COPLEY TOWNSHIP SITE PLAN REVIEW MAJOR SITE PLAN/VARIANCE 4014 MEDINA ROAD STAFF REPORT

January 5, 2026

PROJECT: Former Regal Cinema Redevelopment	
PPN: 1506859	APPLICATION TYPE: Major Site Plan/Variance
LANDOWNER	MSA Montrose LP
APPLICANTS	MSA Montrose LP, c/o Hampton Properties, Inc-Jacob Berger Colliers Engineering-Corey LeBlanc Richard Korris
COMPANY PERFORMING WORK REQUESTED	Colliers Engineering
INVESTMENT	\$5,000,000
APPLICATION SUMMARY	<i>Applicants, on behalf of MSA Montrose LP, are requesting site plan and variance approval to redevelop the former Regal Cinema tenant space.</i>
INITIATED BY	Applicant
DECISION TYPE	<input type="checkbox"/> Informational <input type="checkbox"/> Direction <input checked="" type="checkbox"/> Action
CODE REFERENCES	Section 4.01-C-GR Commercial General Retail Section 13.01 F-Site Plan Review
GENERAL LOCATION	The parcel is in the Market Square at Montrose plaza on the south side of Brookwall Drive and east of Flight Memorial Drive.
LAND AREA	13 acres (Tenant Building 152' x 300')

ARTICLE 4., SECTION 4.01

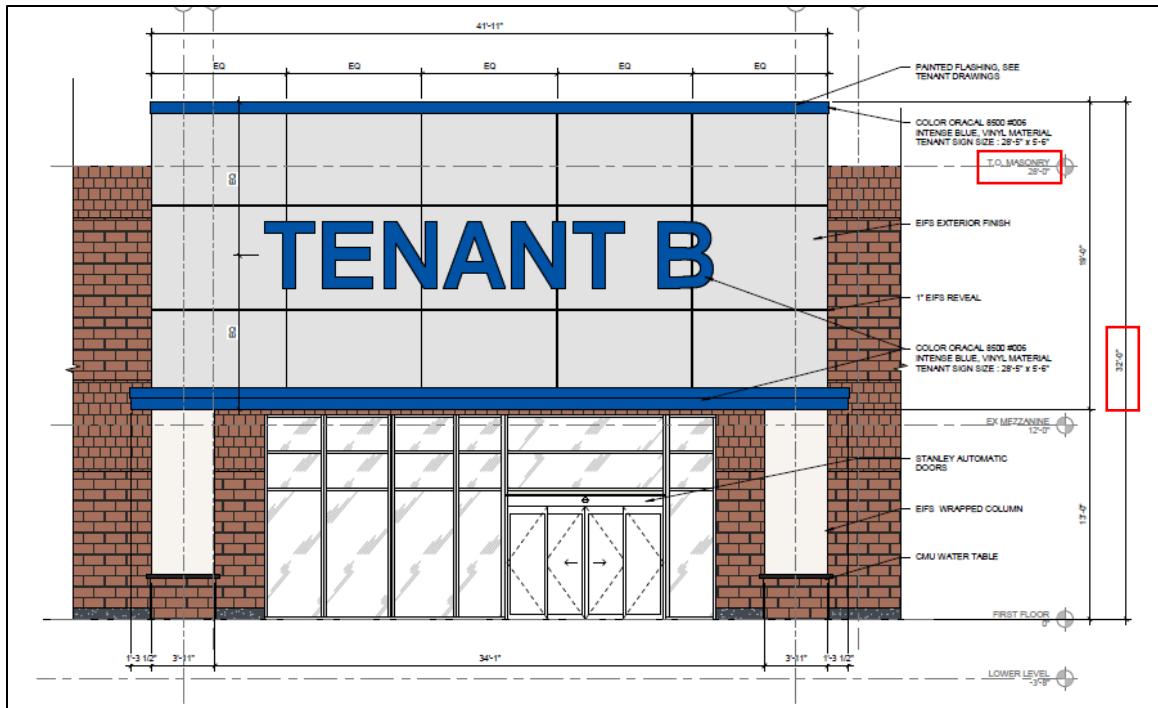
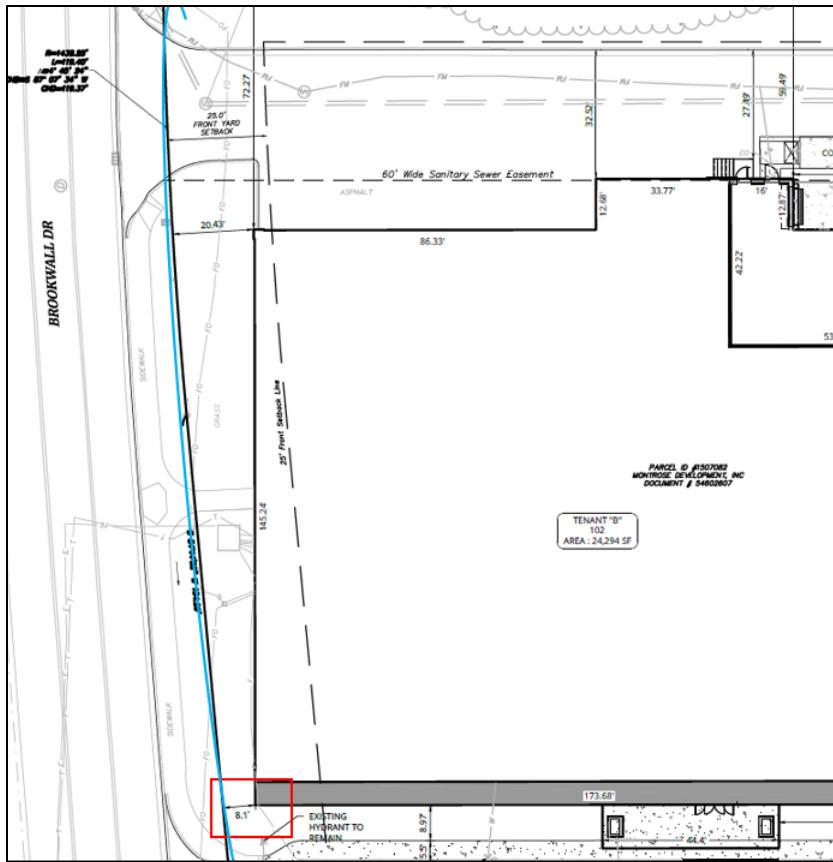
- 50' Minimum Rear Yard Setback (SOUTH)
 - 750' +
- 25' Minimum Side Yard Setback
 - WEST: 59'
 - EAST: 400' +
- 25' Minimum Front Yard Setback (NORTH)
 - 8.1' Non-conforming

Variance Rationale: *The front yard setback is pre-existing and created due to the expanded right of way for the installation of Brookwall Drive. This variance will correct the non-conforming setback.*

The cinema building was constructed in 1988. The 60' Brookwall right-of-way was established in or around 2000.

The **Copley Township Board of Zoning Appeals** motions to (approval/approval with conditions/deny) the applicants variance for a 17' reduction in the required 25' front yard setback for a front yard setback resulting in 8' along Brookwall Drive.
